WASHINGTON MEWS PROJECT

To the Hastings on Hudson Planning Board for October 15, 2015:

We are resubmitting drawings 1-6, 10 and new drawings 15 and 16. There are no revisions to 1 and 2 but these are included for completeness. Drawings 3,4,5,&6 are reissued to show our new roof access provisions to replace the spiral stairs at the West houses, Dwg 10 has been revised to up date open space and parking totals, new drawing 15 illustrates all open space provisions, and new drawing 16 illustrates the location of test wells and building height flags on the existing site.

WASHINGTON MEWS

Sheet Title: **Parking
 Floor Plan**

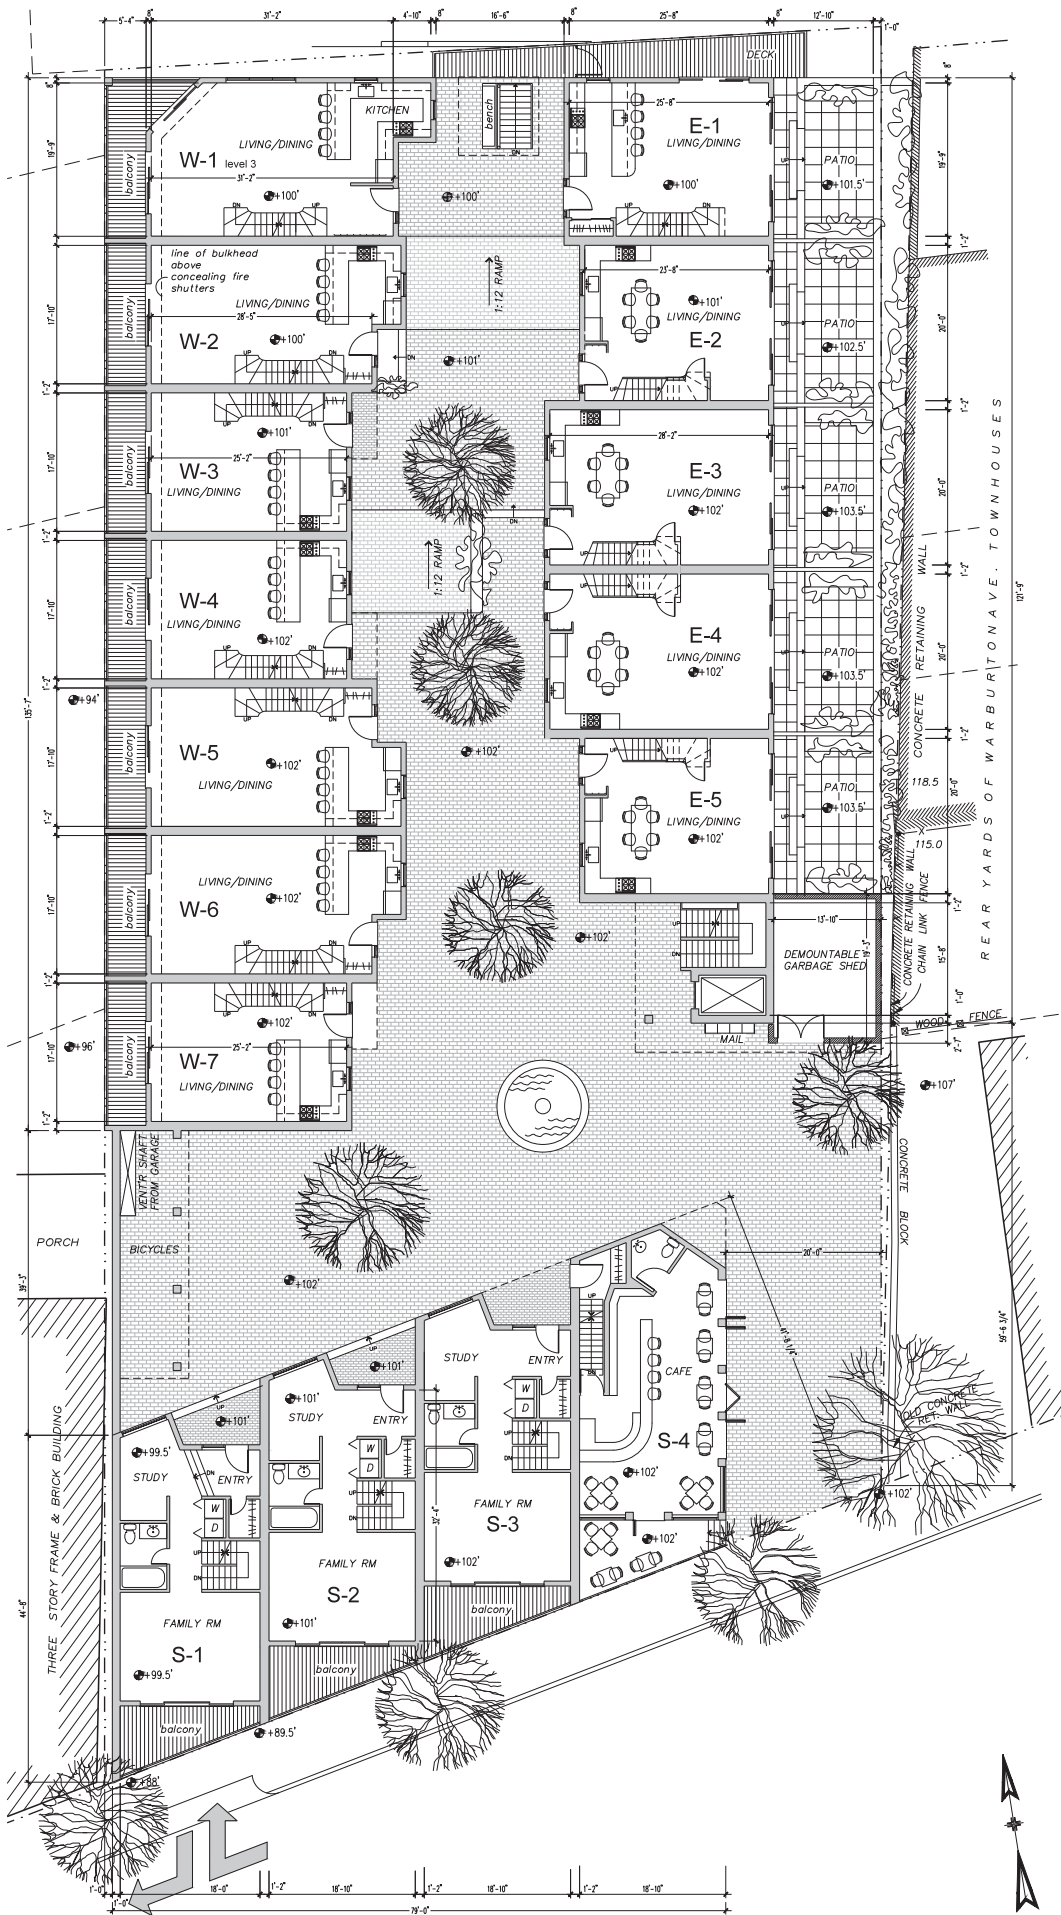
Mr. Minozzi has indicated that he expects that at least one van accessible parking space will be provided in the project regardless of ADA specifications as it is required by the NY State Code. We have not altered Dwg 1 to show this space as he is considering two alternative solutions either one of which is entirely acceptable to us. These are:

(a) Making space #25 the accessible space and leaving the column in the access aisle as is permitted in the State Code. This solution allows for a 20' long access aisle with no difficulty should that ultimately be mandated, but it does place the accessible space some 56' from the elevator.

(b) Making space #4 the van accessible space and #5 the access aisle thereby reducing our total parking count from 25 to 24 spaces and increasing our parking variance requirement to 5 spaces from 4. Space 4 is 24' from the elevator and is the nearest available space.

We will revise our drawing accordingly when a decision is made on this matter.

Sheet Title: **Flag & Well Location**

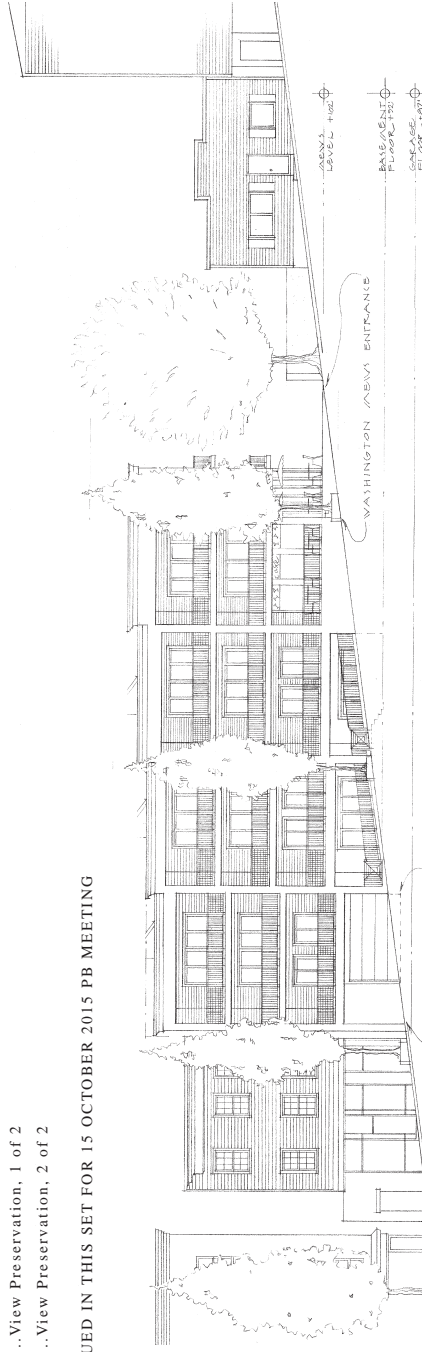
(5) We have added drawing Number 16 which locates the building facades, height flags and subsurface investigation wells in plan atop the site existing condition survey.
